RotorSport UK Ltd Service Bulletin (Permit)

Title: Calidus Control cable clamps		
SB-104 Iss1	Related documents Modification: MC-329 CCAR No.: None	Compliance Category: OPTIONAL or RECOMMENDED or MANDATORY
Applicability		
Aircraft type & model: Calidus	Aircraft serial Nos. affected: RSUK/CALS/any	
The maintenance manual to be referenced is this stated or subsequent issue.		RSUK0061 Iss6
<p>This form is the response from RotorSport UK Ltd either against a problem found in the product in service requiring a containment or rectification action, or as service information for aircraft modification incorporation. For help, contact RotorSport on 44(0)1588 505060, or email compliance@rotorsport.org.</p> <p>The technical content of this document is approved under the authority of the UK CAA Design Organisation Approval Ref: DAI/9917/06</p>

Fig 4 Positioning the pitch clamp

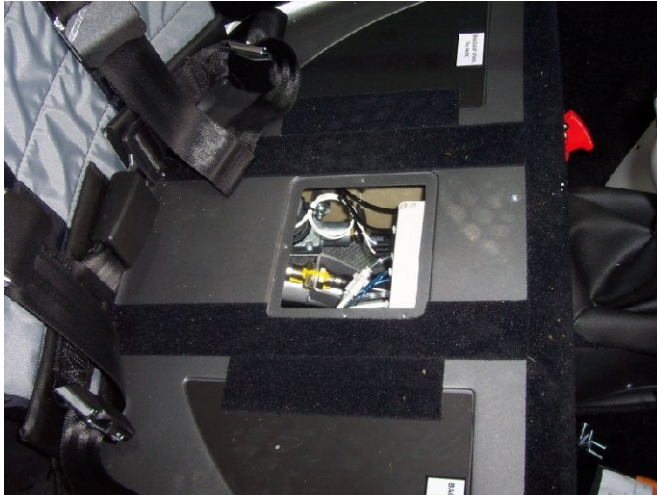
4. Apply Loctite 243 to one screw and fit one clamp to the pitch control cable. (Use locking tweezers to hold the clamp in position so that the clamp is beneath the access hole and clear of contact with the body – see Figs 4 and 5)

Fig 6 Access hole and blanking grommet

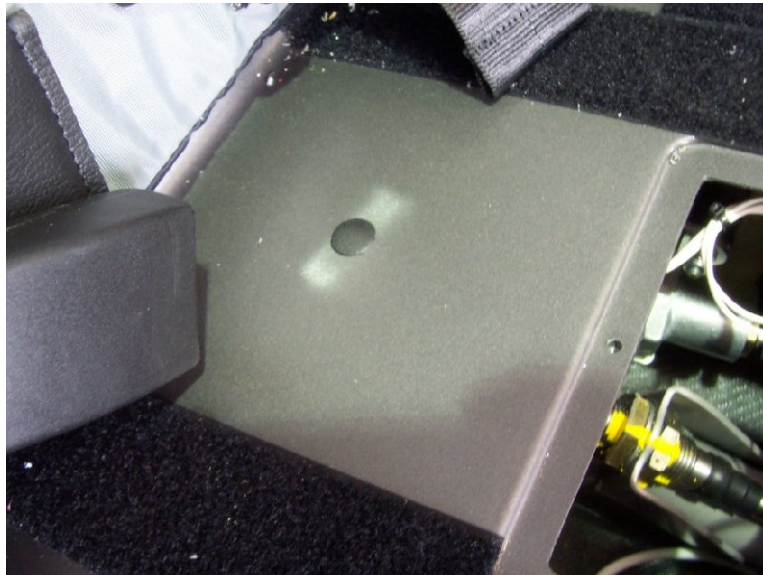
3. Pilot drill a hole through the seat base on the centre line approximately 80mm from the root of the rear bulkhead. Open-out to 12mm diameter to suit the blanking grommet.

5. Apply Loctite 243 to the second screw, attach to an allen key by means of a magnet and pass through the access hole into the clamp
6. Ensure clamps are fitted, and any cut cable ties replaced, such that the clamp components cannot rub or fret to the aircraft or other cables in the centre channel, or contact the aircraft body.
